# Urgent Field Safety Notice

## SBN-SIS-2019-002

### Loose screws on the Tray Input Flap of the cobas p 501 /p 701 post-analytical units

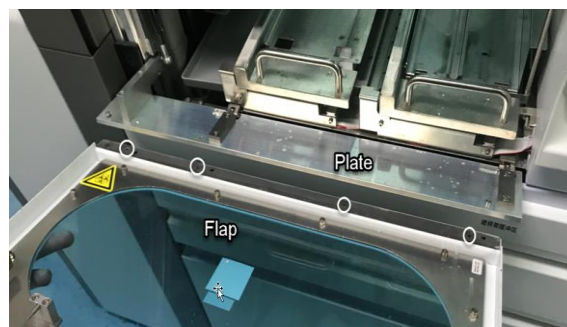
The Tray Input Flap screws can become loose on the cobas p 501 or p 701 post-analytical units resulting in the potential detachment from the instrument.

Visual inspection of the Tray Input Flap, plate and screws were performed. As demonstrated in the pictures below, the flap was no longer attached to the instrument and the 4 M3 threads on the Tray Input Flap were worn out resulting in the screws not working as intended.

The Tray Input Flaps on instruments with the above listed serial numbers must be replaced by Roche Diagnostics with the current design of the tray input flaps with an estimated completion date of 30-September-2019.
